CHANGE	REQ		Please see embedded help age for instructions on how			
			12.15	CR	A019 rev 2	Current Versi	on: 7.4.0		
GSM (AA.BB) or	3G ((AA.BBB) specific	ation number \uparrow			mber as allocated by MCC	support team		
For submission to: SA#7 list approval meeting # here ↑			for approval X for information			strategic (for SMG non-strategic use only)			
Proposed change affects: (U)SIM ME UTRAN Core Network (at least one should be marked with an X) (U)SIM ME UTRAN Core Network						X			
Source:		Nokia				Date:	17-03-2000		
Subject:		GTP' head	<mark>er length fixing, r</mark>	2					
Work item:		Charging							
Category: (only one category shall be marked with an X)	F A B C D	Addition of featureRelease 97Functional modification of featureXRelease 98							
<u>Reason for</u> <u>change:</u>		A corresponding R99 CR was approved by TSG-SA#7 (CR 32.015-A002). A technically identical R98 CR, to TS 12.15, was however not approved by TSG-SA#7. Current situation is not acceptable to the industry since this means two variations of the same version of GTP' protocol. This makes interoperation of 2G and 3G networks impossible. One main target of 3GPP has been the evolution of core network protocols

Figure 12: Start of the GTP/GTP' header

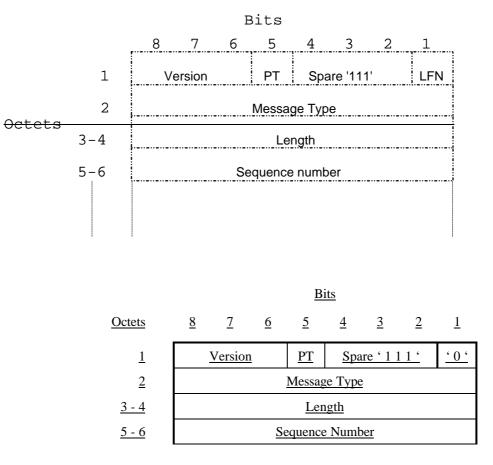
The GTP header length which previously had always fixed length, has been changed after the GSM 09.60 specification stabilisation to have in e.g. 3G TS 29.060 3.3.0 a variable length. Now it is not possible for CGF (which does not even use GTP) to know how long the GTP' header should be, if the GTP' header would still be stated in GSM 12.15 / 3G TS 32.015 specifications to be "the same as in GTP". Therefore the GTP' header length should be defined to be just what it really is: 6 octets long. (By so far the GTP' header has been defined to have so many dummy octets after the 6 needed octets, that the total header length would be the same as in GTP. Anyhow, such assumption does not any more work, since the GTP header length is not any more always 20 octets.) The GTP' version becomes thus v2 and the GTP' Version bits are correspondingly set binary '010' in the header. Advantages: Compatibility and interoperability problems avoided. Better bandwidth usage as the previously carried dummy octets 7-20 are avoided. The CGFs can be independent of the generation (GPRS/3G/XX) and GTP subversions. Operators can get CGF service and redundancy with a lower price, as the CGFs can simultaneously serve different generation GSNs.

The <u>start of the GTP</u> header defined in GSM 09.60 is reused. In GPRS charging, only the signalling plane of GTP is <u>partly re</u>used.

LFN flag (LLC Frame Number flag) Bit 1 of octet 1 is not used in GTP' (except in v0), and it is '0' in the GTP' header.

LLC Frame Number in GTP' header is always set to 255 by the sender and shall be ignored by the receiver.

TID is the tunnel identifier that points out MM and PDP contexts. In GPRS charging, it is not used, and it is always 0.

GTP' version 2 (binary '010') is the same as version 1, but the header is just 6 octets long. No unused trailing octets.
